Report to the Future Melbourne Committee

Ministerial Planning Referral: TPM-2023-14 435-437 St Kilda Road, Melbourne

7 May 2024

Application number:	TPM-2023-14
DTP Application number:	PA2302457
Applicant:	Urban Planning Collective
Owner:	Boulevard Properties Pty Ltd
Architect:	Bates Smart
Address:	435-437 St Kilda Road, MELBOURNE VIC 3004
Proposal:	Use and development of the land for multi-dwelling development
Cost of works:	\$75 million
Date received by City of Melbourne:	7 September 2023
Responsible officer:	Nathaniel Man, Manager Statutory Planning

General Arrangement Plan Level GF

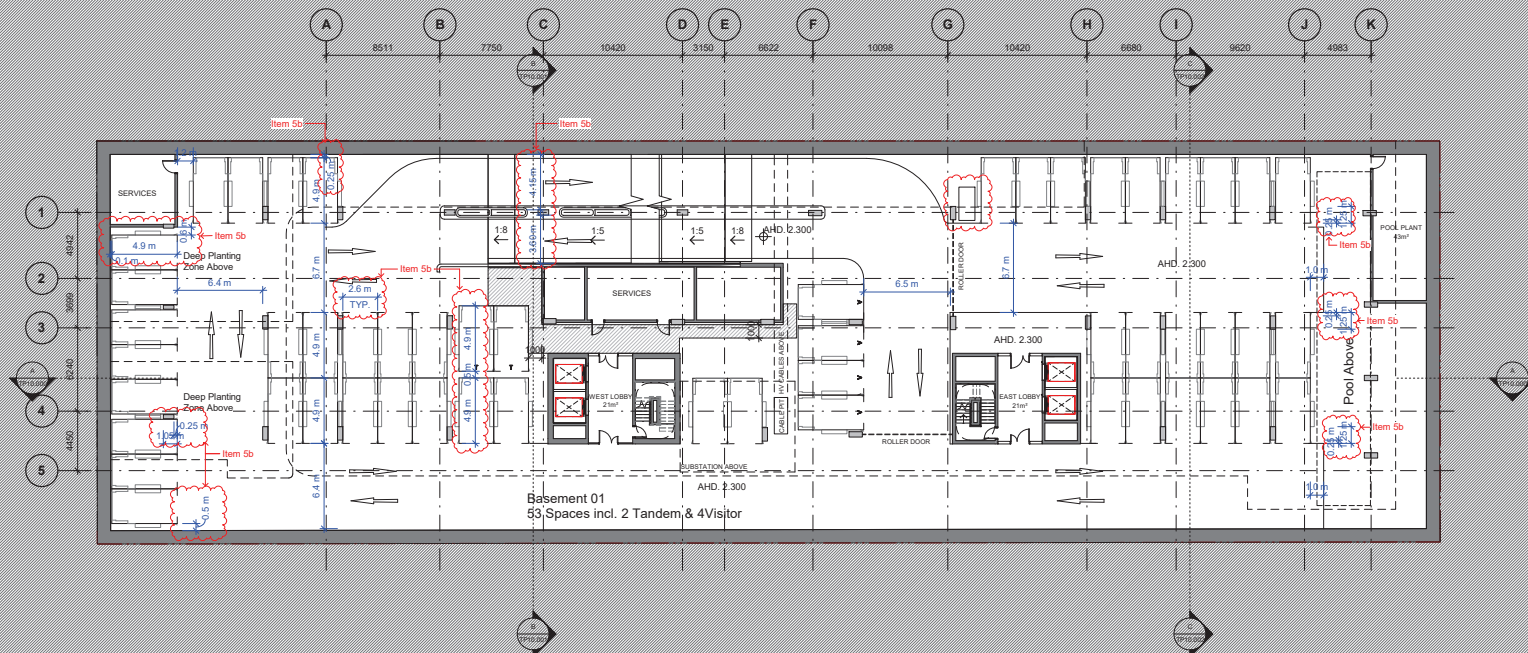
8. The proposal includes a porte cochere forward of the ground level lobby area, which is not supported. An extension to the foyer and concierge area is recommended to provide greater amenities to future residents and improves legibility between public and private realm.

Figure 8 - A diverse height and scale of built form along St Kilda Road.

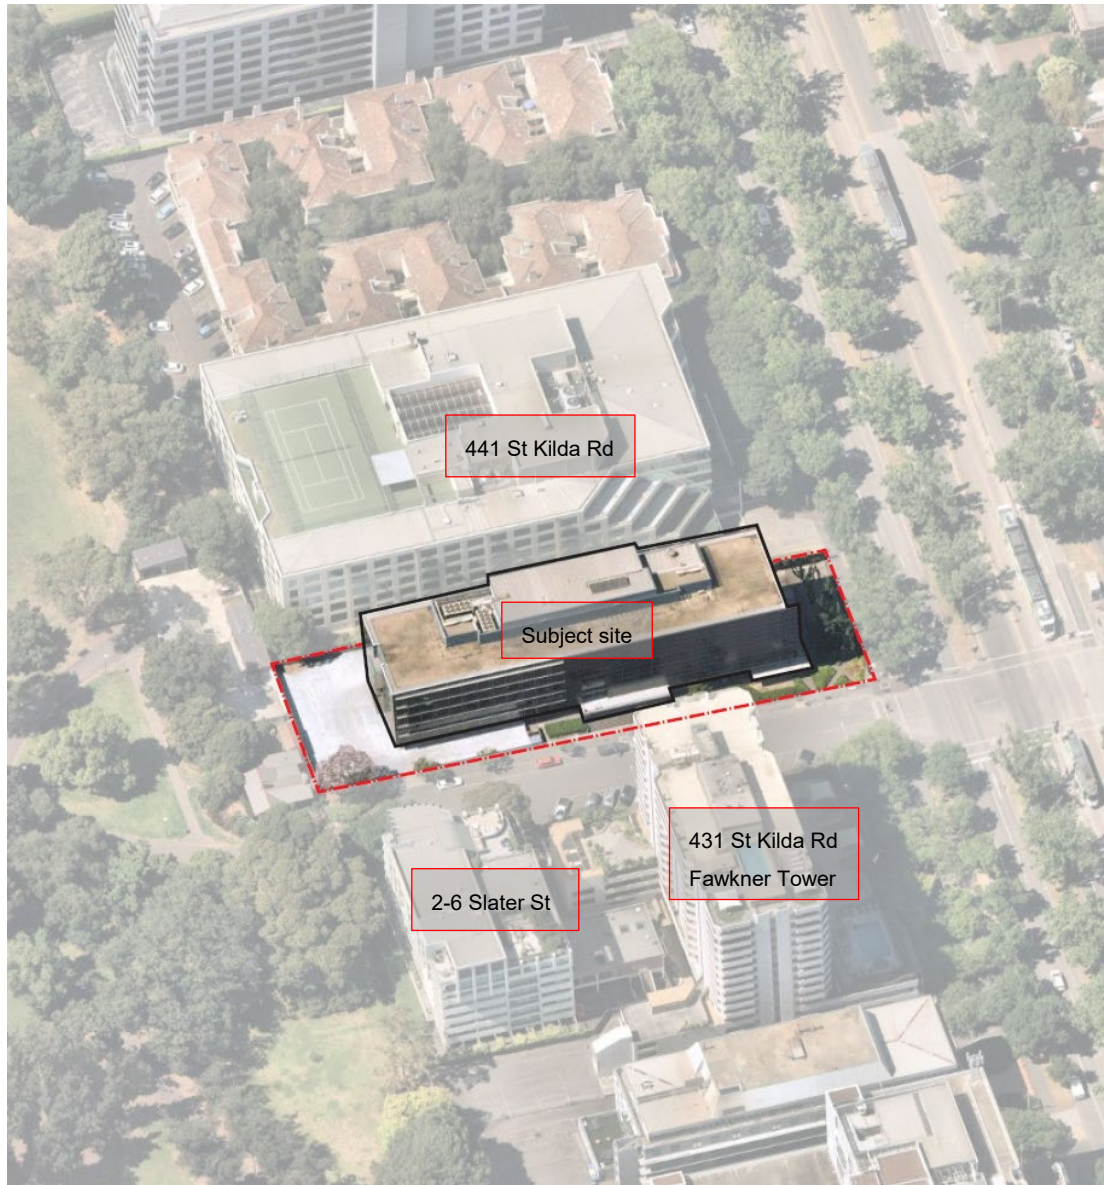
From a further distance, taller built form is evident; and the proposal will be well setback between existing vegetation along the nature strips of both St Kilda Road and Slater Street, as well as that proposed within the subject site, provided that the private terraces extending into the side setbacks associated with the eastern most apartments on Level 1 is removed as per the site setbacks requirement under Table to DDO19. This will be further discussed in response to the Table in DDO19 section below.

Figure 9 - Daylight analysis of Levels 2, indicating acceptable daylight access in living and dining area of centrally located apartments within the building's podium levels.

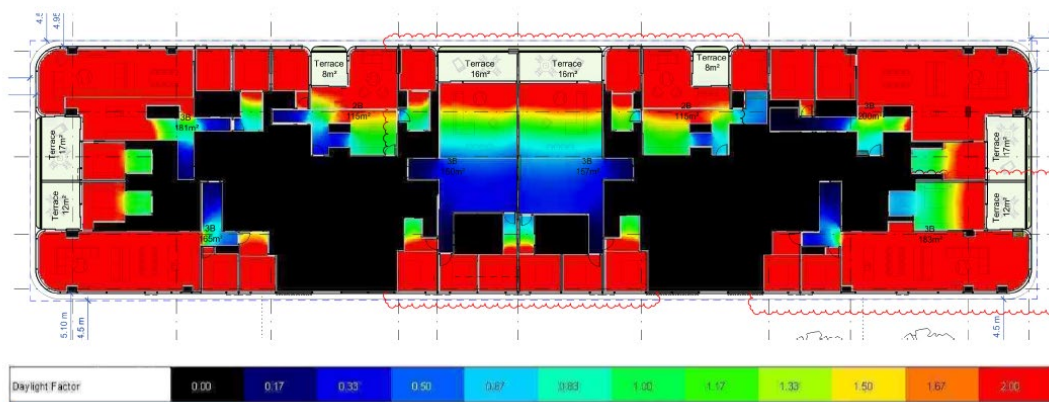
- These apartments have a floor to ceiling height of 2.7 metres, and all living and dining areas are located within 9 metres when measured from the balustrade of the balconies with overhangs above (refer to Figure 9 for daylight analysis).

- When taking the entire development into consideration, these eight dwellings equate to 10.38 percent of the overall development that does not meet the numerical standard under Clause 58.07-2.
